From: Griffin, Tim (Contractor)
Sent: 15 August 2024 17:43
To: Harrison, Liz
Cc: Dyer, Tim; Ellison, Mark; Oliveira, Marta (Contractor)
Subject: Re: F/23/96629 Land at Fieldfare Road - landscape comments on revised scheme

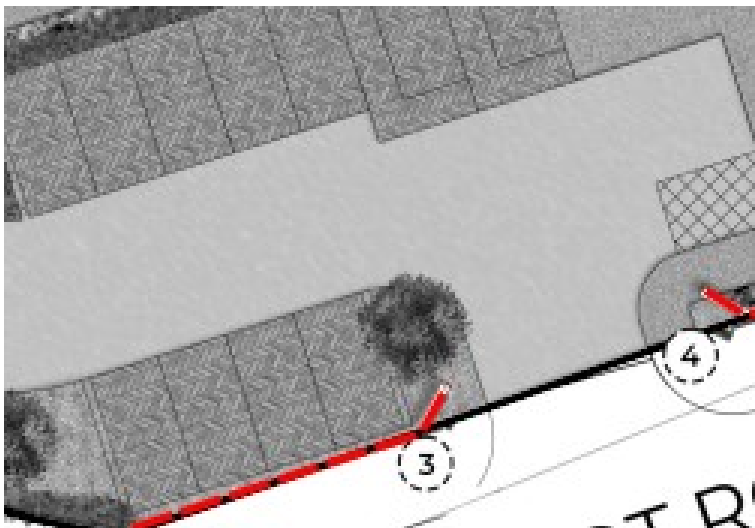
The coloured landscape masterplan that has been prepared is helpful in assessing the proposals, however, the layout has not substantially improved from previous iterations and has not responded positively to my previous comments.

My primary concern remains that the size and form of the proposed Care Home significantly limits Green Infrastructure planting that would help create an attractive setting for the new facility. In too many places around the boundaries there are pinch points. These either prevent any planting at all to soften the development edge or leave such narrow strips of soft landscape that the indicative boundary hedge planting is likely to fail.

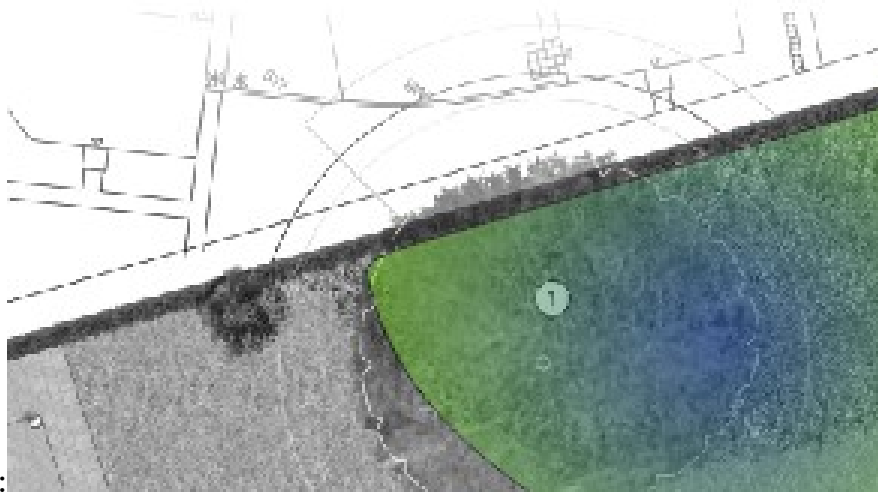
The suggested boundary brick wall and railings will create significant issues for the suggested hedge planting as the concrete footing will reduce rooting volume. I recommend that wherever a boundary hedge is shown that the enclosure should be railings only as these require much reduced footings. The brick wall and railings could be retained either side of the entrance where there is no space for planting (red dashed lines below).

In the areas highlighted below the new hedge is predictably likely to fail as the rooting area is too restricted. This will open up gaps in boundary screening:
